**PLATINO**  
Arduino, ISP, FTDI

150555-I

150555-1-Platino-v1.4b

Sheet: 3/3

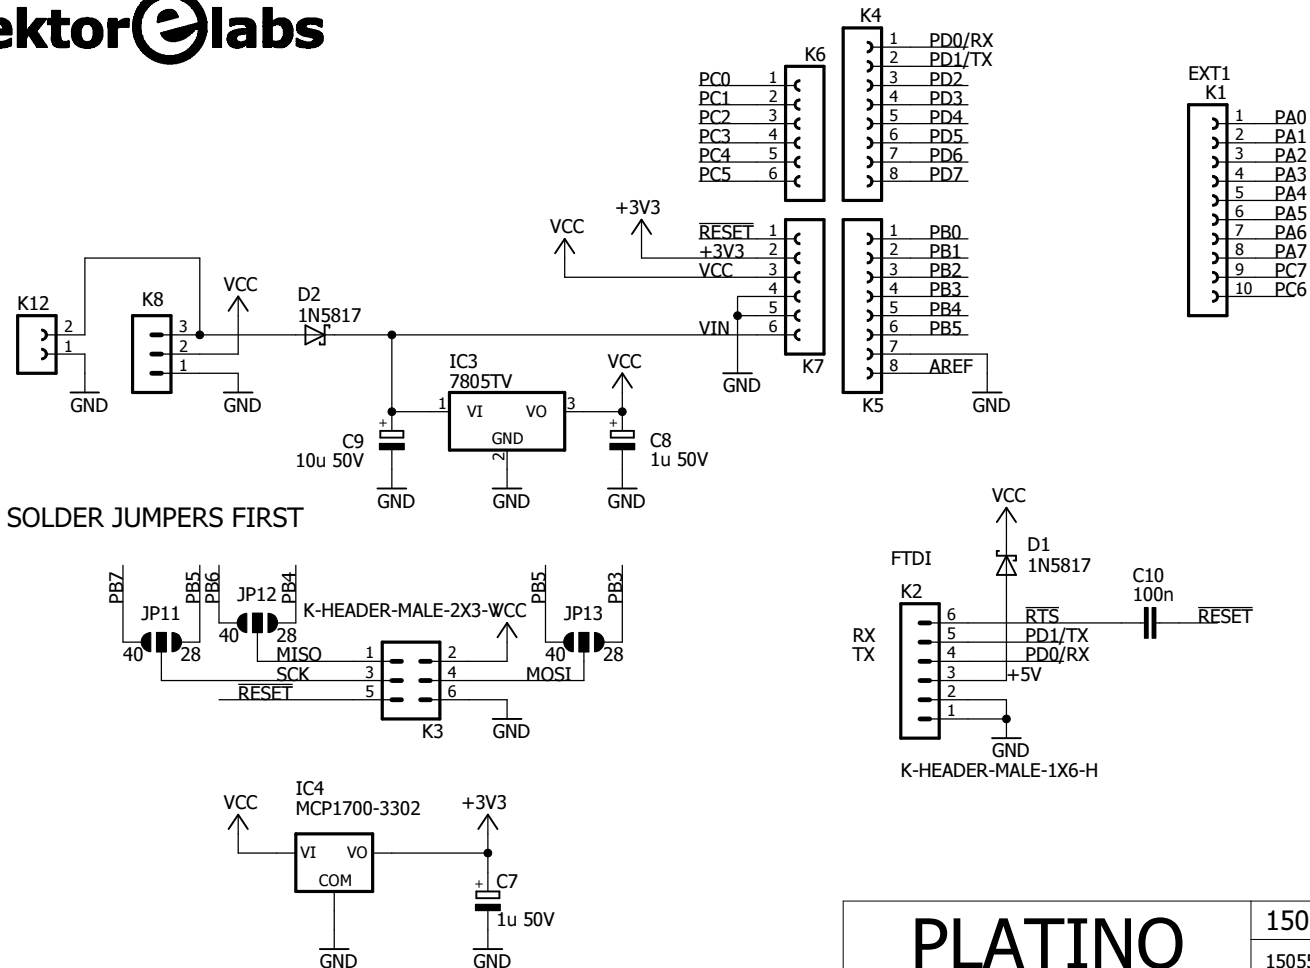
Changes since v1.3

- Added K12 2-way power terminal block
- Added IC4 + C7 for on-board 3V3 regulation
- Added D3 for protection in case both FTDI cable and external power are present
- Added JP15 & JP16 to allow use of second UART available in DIP-40 devices
- Deleted JP2 because no longer needed
- PCB silkscreen touched-up
